Service Information

HB545/A HB545/B
HB546/A HB546/B

DAP 326

COMBI SOLARIUM

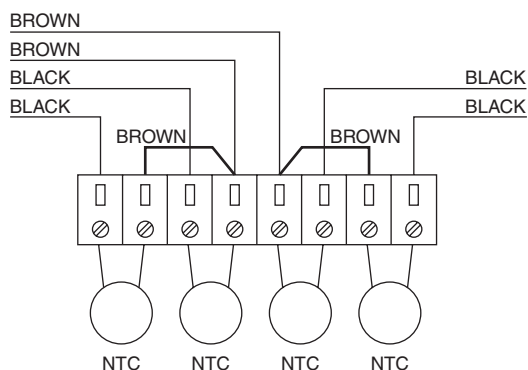
The introduction of different inrush current limiting components as from production code 0101 has resulted in a type number change into **HB545/B** and into **HB546/B**, see diagram below.

A burned NTC resistor or overheated wiring points to a wiring fault at the connecting block.

The correct wiring is shown below.

The newly introduced parts are:

4222 062 94580 NTC resistor 22Ω

4222 062 94600 capacitor 50μF/250V

4222 062 94570 connecting block 8 sections
